PIC18F87J11 Family Silicon Errata and Data Sheet Clarification

The PIC18F87J11 family of devices that you have received conform functionally to the current Device Data Sheet (DS39778E), except for the anomalies described in this document.

Data Sheet Clarifications

64-Pin TQFP

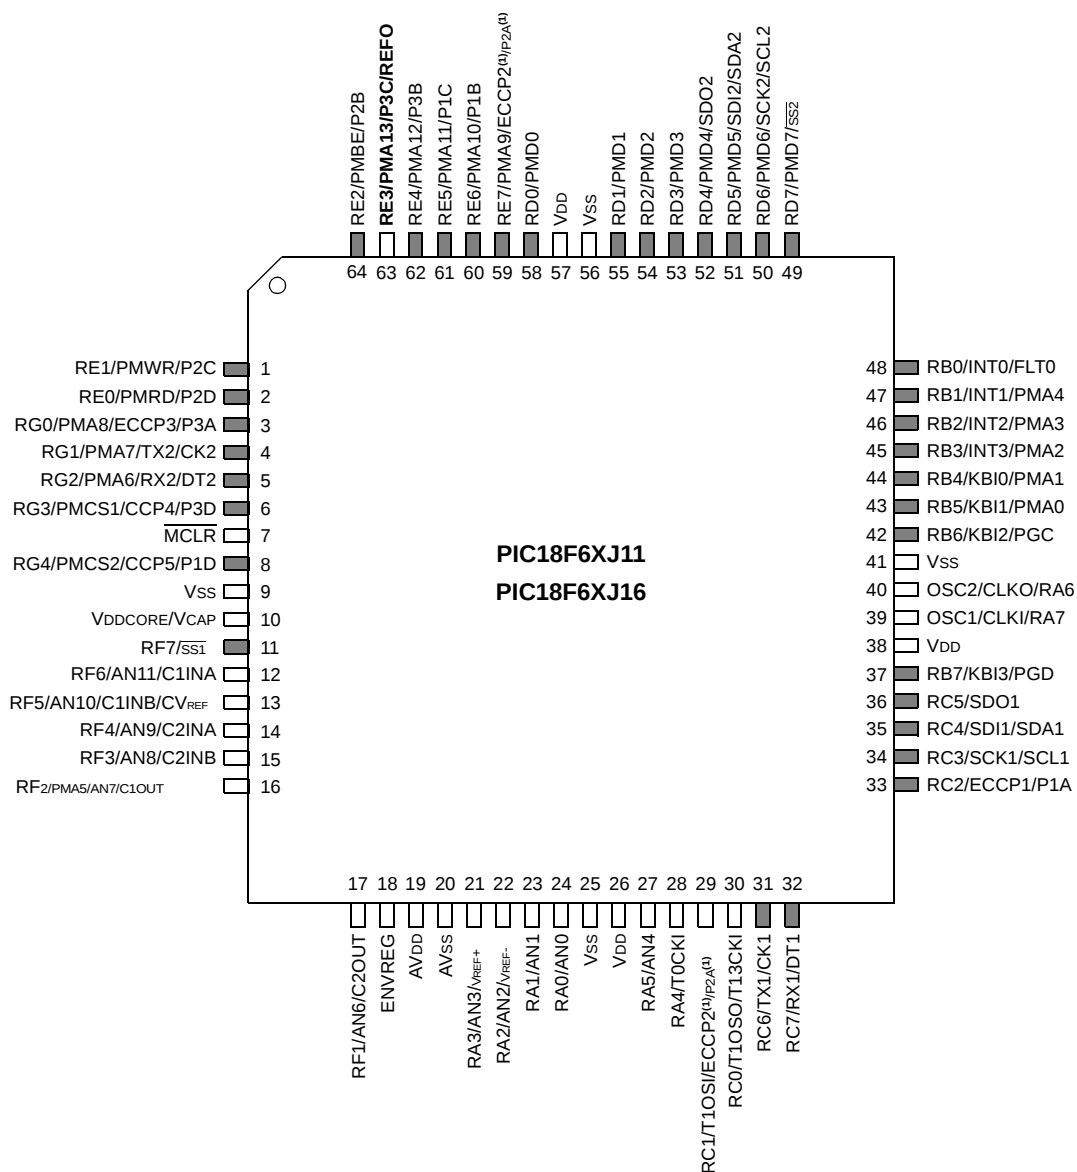
1. Module: I/O Ports

PORTE pin RE3 is not +5.5V tolerant as indicated in the data sheet. The pin diagrams should be corrected to read as follows:

Legend: Shaded pins indicate pins that are tolerant up to +5.5V.
